Access Compliance Report Public Rights-of-Way (Curb Ramps)

Main Street: N/A Cross Street: O_NEILL_DR Location: SE

ADA ID: RPRK220223165650 Ramp Type: Type 6 - Directional 1 Initial Pass/Fail: Pass Overall Compliance: No Severity Score: 15

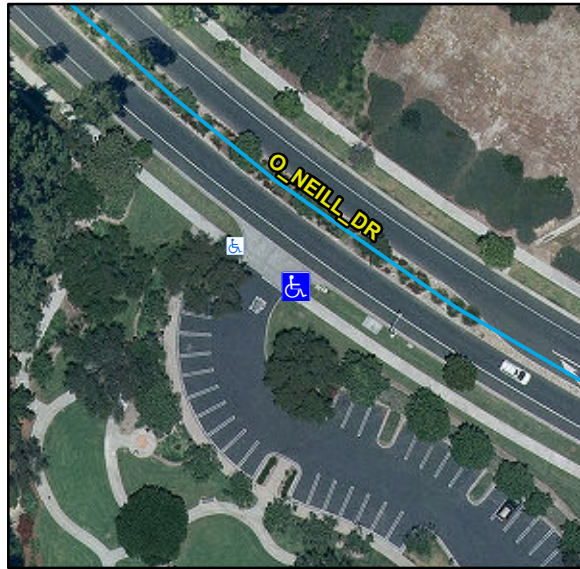
Compliance	Description	Data	Compliance	Description	Data
N/A	Ramp Length (in)	100	Yes	Flare Type LT	
Yes	Ramp Width (in)	72			Curbed2
Yes	Ramp Run Slope (%)	1	N/A	Flare Slope LT (%)	N/A
Yes	Ramp Cross Slope (%)	1.4	N/A	Flare Traversable LT	N/A
No	Grade Break	No	Yes	Flare Type RT	
N/A	Grade Break Slope (%)	N/A			Curbed2
N/A	Grade Break Cross Slope (%)	N/A	N/A	Flare Slope RT (%)	N/A
	Addl Para Ramp Left?	No	N/A	Flare Traversable RT	N/A
	Addl Para Ramp Right?	No	No	DWS Provided	No
N/A	Landing Present	Yes	N/A	DWS Contrast	N/A
Yes	Landing Length (in)	122	N/A	DWS Length (in)	N/A
Yes	Landing Width (in)	72	N/A	DWS Full Width	N/A
Yes	Landing Run Slope (%)	1.2		DWS Offset Type	N/A
No	Landing Cross Slope (%)	2.8	N/A	DWS Left Offset (in)	N/A
N/A	Landing Movement Obstructed?	No	N/A	DWS Right Offset (in)	N/A
	Landing Movement Type	N/A			
N/A	Landing Shared	No			
N/A	Marked Crosswalk 1	No	N/A	Clear Space	N/A
	Crossing 1 Direction	W	N/A	Clear Space To Crosswalk (in)	N/A

Marked Crosswalk 1 Width (in)	N/A			
N/A	Ramp Inside Crosswalk 1	N/A			
	Crossing 1 Slope (%)	2.7			
	Crossing 1 Cross Slope (%)	2.6			
Yes	Gutter Ponding	No	Yes	Curb Slope	1.3
Yes	Gutter Lip Height (in)	0		Road Run Slope (%)	N/A
No	Gutter Run Slope (%)	6.3		Road Cross Slope (%)	N/A
No	Gutter Cross Slope (%)	4.9		Parallel Ramp Side	N/A
Yes	Overall Surface Condition	Acceptable	Yes	Perp Joint Present	Yes
	Cross Gutter Present?	Yes		Spandrel Present?	Yes
	Replace Cross Gutter?	No		Replace Spandrel?	No

Remove & Replace Entire Ramp. Remove & Replace Gutter.

R304.5.3, R304.5.2, R305, R304.5.4, STD 1115
